## SALES BULLETIN

September 25, 2017

### SF-Q and SF-FQ ELECTRODE WIRE ASSEMBLY CHANGE

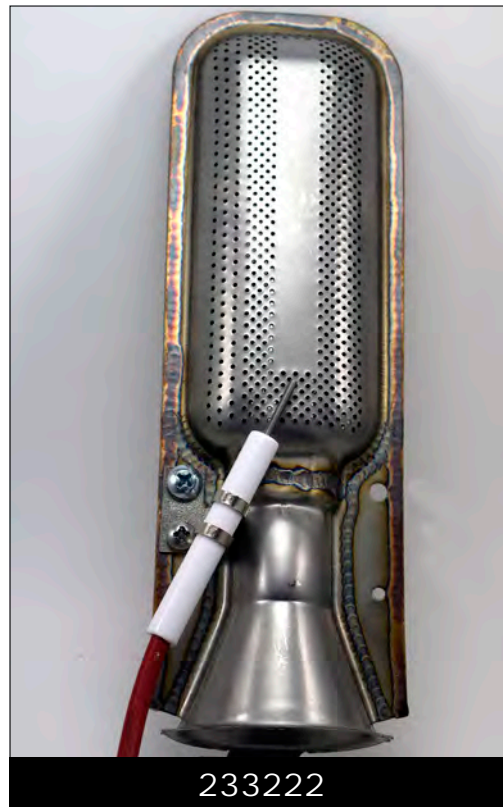
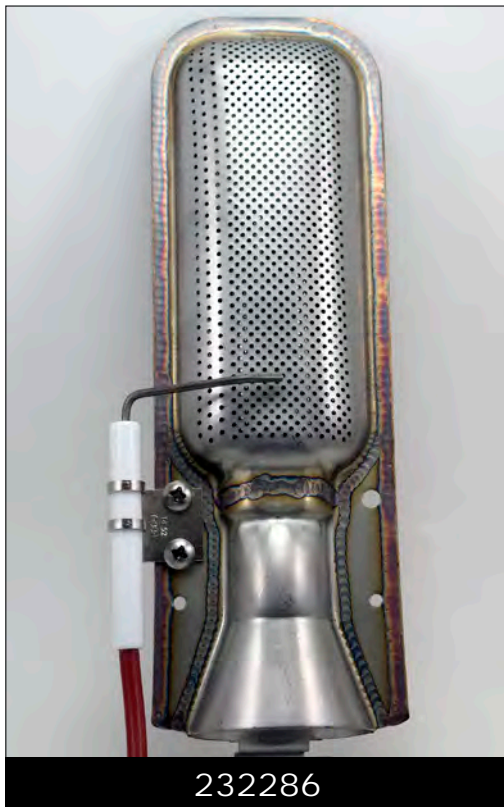
On models SF20/25/30/35Q and SF20/25/30/35FQ furnaces, the electrode wire assembly has been changed to part number 233222 effective April 3, 2017 (04-03-2017). This production change also includes the removal of the two top secondary plates and tinnerman clip.

**PLEASE NOTE:** parts are not interchangeable or backward compatible. Part number 233222 must be installed on SF20/25/30/35Q and SF20/25/30/35FQ furnace models. NOTE: The photos below are used to illustrate the electrode design change.
